UNITED STATES			OCD-HO	APPROVED	
(Abgust 2007) UNITED STATES DEPARTMENT OF THE INTERIOR BUREAU OF LAND MANAGEMENT SUNDRY NOTICES AND REPORTS ON WELLS Do not use this form for proposals to drill or to re-enter an HOBBS OCD abandoned well. Use form 3160-3 (APD) for such proposals. SUBMIT IN TRIPLICATE - Other instructions on reverse side SEP 39 2003 1. Type of Well Oil Well Gas Well Ø Other: INJECTION				OMB NO. 1004-0135 Expires: July 31, 2010 5. Lease Serial No. NMNM56265 6. If Indian, Allottee or Tribe Name		
			BSOCD 6.			
			And in the local division in the local divis			
			RECEIVED 8. Well Name and FEDERAL L 1		No.

2. Name of Operator Contact: VICKI JOHNSTON NEARBURG PRODUCING COMPANYE-Mail: vjohnston1@gmail.com			9.	9. API Well No. 30-025-20811		
		Phone No. (include area code 830-537-4599	io. (include area code) 10. Field and Po 37-4599 SWD; YAT		ol, or Exploratory ES-SEVEN RIVERS

4. Location of Well (Footage, Sec., T		11. County or Parish, and State				
Sec 25 T20S R34E Mer NMP	SENW 1650FNL 1980FWL	-		LEA COUNTY,	NM	
12. CHECK APPI	ROPRIATE BOX(ES) TO INE	ICATE NATURE OF	NOTICE, REPO	RT, OR OTHE	ER DATA	
TYPE OF SUBMISSION		TYPE O	TYPE OF ACTION			
Notice of Intent	Acidiz

PROPOSED WELLBORE DIAGRAM

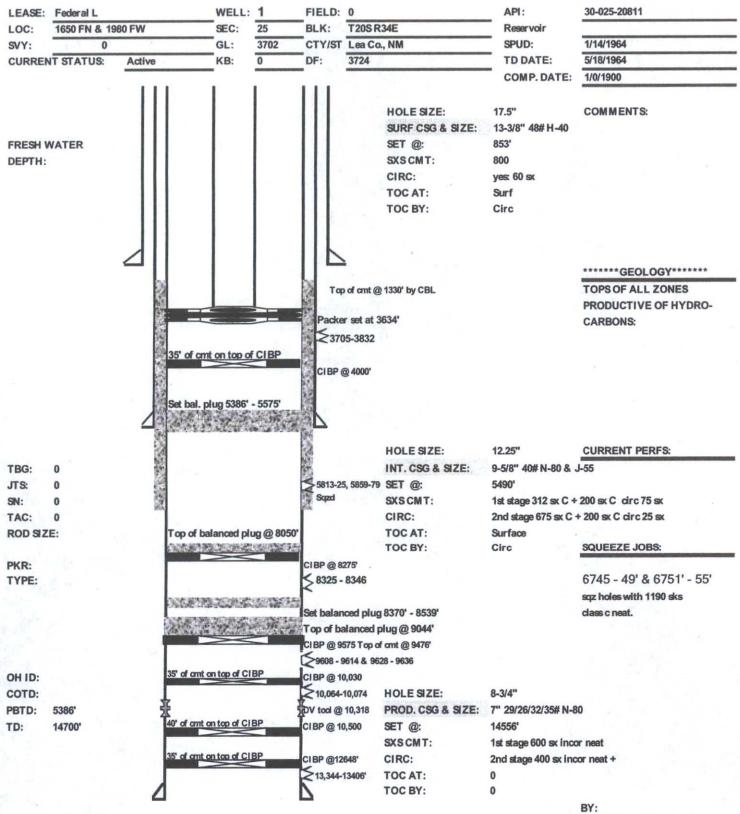
Completion Report was submitted on May 21, 2015. Please see attached revised Proposed Wellbore Diagram.

Attach the Bond under which the wor following completion of the involved testing has been completed. Final Ab determined that the site is ready for fin Per Maxey Brown-NMOCD (in CIBP at 4,000'. Procedure: MIRU Pulling Unit. ND wellhe EUE 8rd (IPC) tbg. LD 2-7/8" CIBP/CCL to 4000'. Set CIBP putting 35' cement on top of C 2-7/8" x 7" AS 1x pkr w/1.875" internally coated) tbg. Set pact out plug. Release from On/Of down tbg and out casing w/15	eration (clearly state all pertinent detailly or recomplete horizontally, give st k will be performed or provide the Bo operations. If the operation results in andonment Notices shall be filed only nal inspection.) compliance with Order SWD-1 ad and NU BOP. Release pac x 7" AS 1x pkr w/1.875" F profi at 4000'. POOH w/Baker setti IBP. TOC @ 3965'. POOH & F profile & T2 On/Off tool, 111 ker at 3634' in 15,000# compre f tool and PU several feet off po 0 bbls 2% KCL water w/double OP & NU wellhead. Pump out true and correct. Electronic Submission #312733	Is, including estimated startin ibsurface locations and meas nd No. on file with BLM/BL a multiple completion or rec after all requirements, include (471), Nearburg Product ker and POOH with 111 le w/T2 On/Off tool. RI ing tool. RIH w/cement LD dump bailer. PU & jts 2-7/8" L-80 6.5# EU ssion w/BOP still on we acker. Close BOP rams inhibited packer fluid. plug and perform inject	ng date of any propos ured and true vertica A. Required subseque ompletion in a new i ding reclamation, hav sing Company wi l jts 2-7/8" L-80 ft H with 7" dump bailer, RIH w/redressed JE 8rd (TK-70 bll. RIH w/pump s. Circulate Latch back on to tivity test.	eed work and appro I depths of all perti- tent reports shall be nterval, a Form 31 ve been completed, Il set a 5.5#	nent markers and zo e filed within 30 day 60-4 shall be filed o

Perform Mechanical Integrity Test (MIT) on casing, holding 500# for 30 minutes and record on chart. RDMO workover rig and rental tools. Turn well to injection.
